CITY OF BLOOMINGTON

APRIL 18, 2013 @ 5:30 p.m.
COUNCIL CHAMBERS #115
CITY HALL

BLOOMINGTON BOARD OF ZONING APPEALS
STAFF REPORT
Location: 2211 S. High St.

CASE #: UV-13-13
DATE: April 18, 2013

**UV-13-13
 Site Plan**

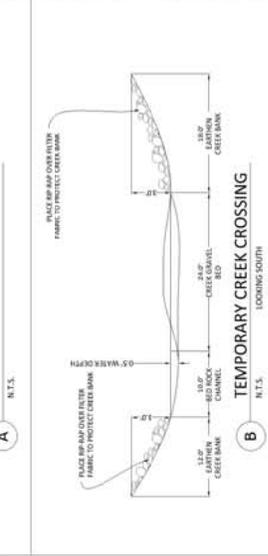
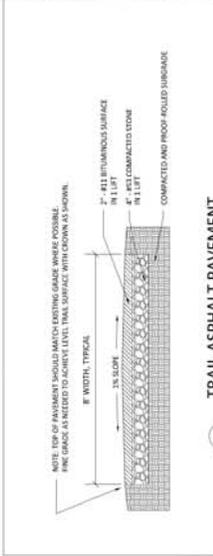
- 1.) If the Petitioner is granted a floodplain variance, they should choose a different material than petroleum asphalt to use as a surface.

- 2.) If the Petitioner is granted a floodplain variance, they should plant a code-compliant riparian buffer to provide the ecological services that they provide.

STAFF RESPONSE: Staff has discussed the possibility of using alternative surfacing materials for the path. The petitioner has indicated that the alternative materials, besides not providing a conducive surface for walking, rollerblading, skating, each have their own set of problems. Paver stones are cost prohibitive and bark mulch or similar material would be washed away in any high water events and do not provide a solid surface.

STAFF RESPONSE: Staff supports this request and will work with the petitioner to come up with a planting plan for the riparian areas consisting of native, wetland plants.

① FIRST FLOOR PLAN
SCALE 1/4" = 1'-0"

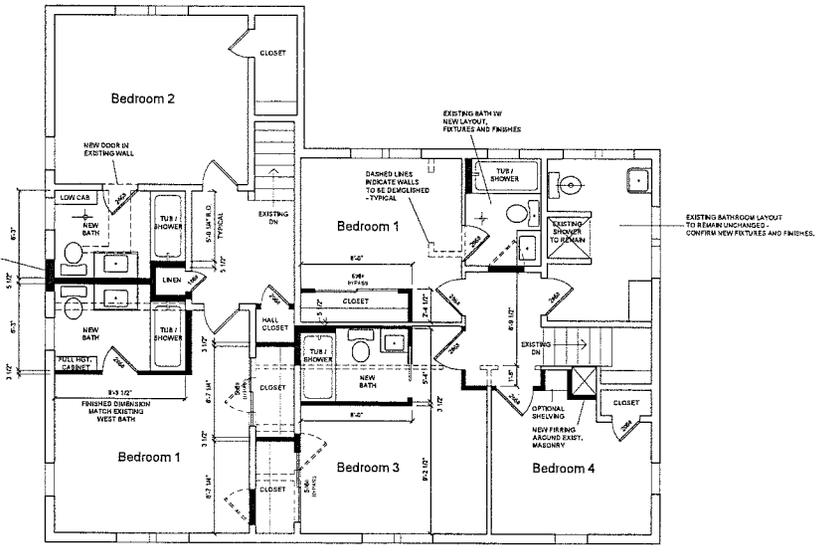
DEMOLISH EXISTING CONCRETE BLOCK STOOP - REPLACE WITH NEW TREATED WOOD LANDING AND STEPS - STAIR TREADS TO BE REORIENTED TO THE SOUTH AS SHOWN. HOLD OFF WALL TO AVOID EXISTING WINDOW AS STAIRS DESCEND

Would become kitchen

Door Opening would walled off
